Indianapolis Historic Preservation Commission (IHPC) **HEARING AGENDA**

Wednesday, May 7, 2025, 5:30 P.M.
2nd Floor, Public Assembly Room, City-County Building
200 East Washington Street, Indianapolis, Indiana

Indianapolis Historic Preservation Commission (IHPC) **STAFF REPORT**

Notated Staff Comments

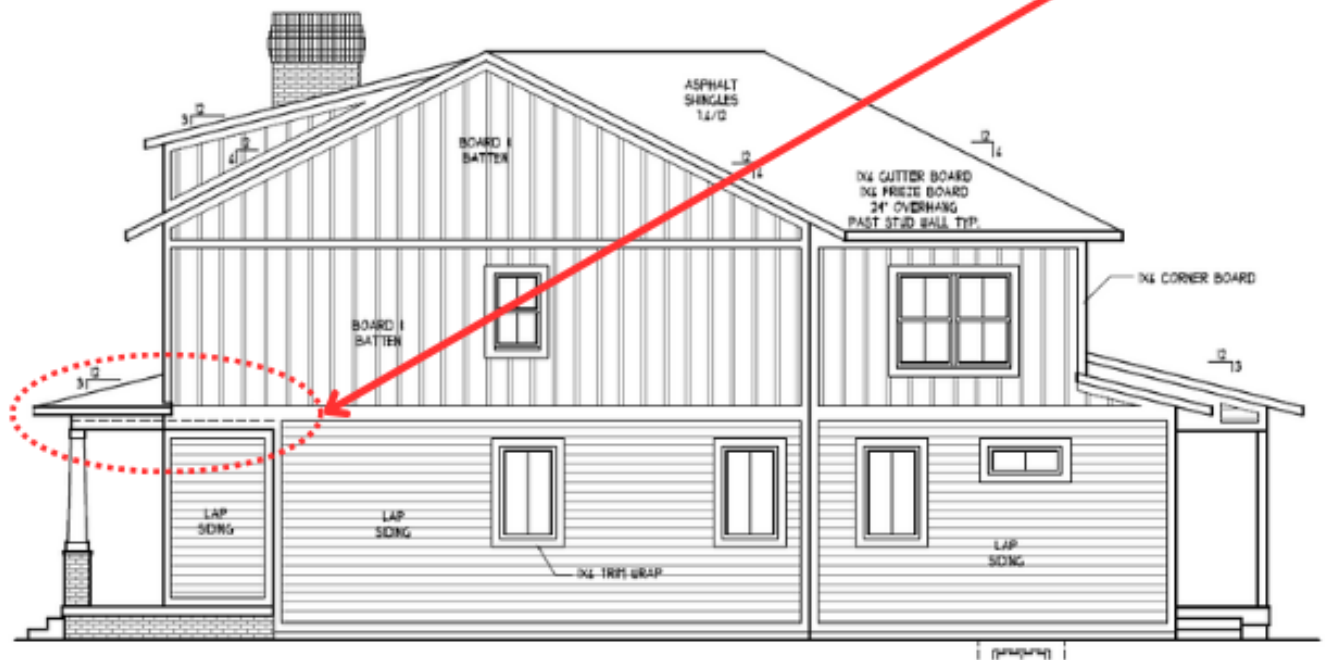
Notated Staff Comments Continued

Band board needs to match south elevation (see below)
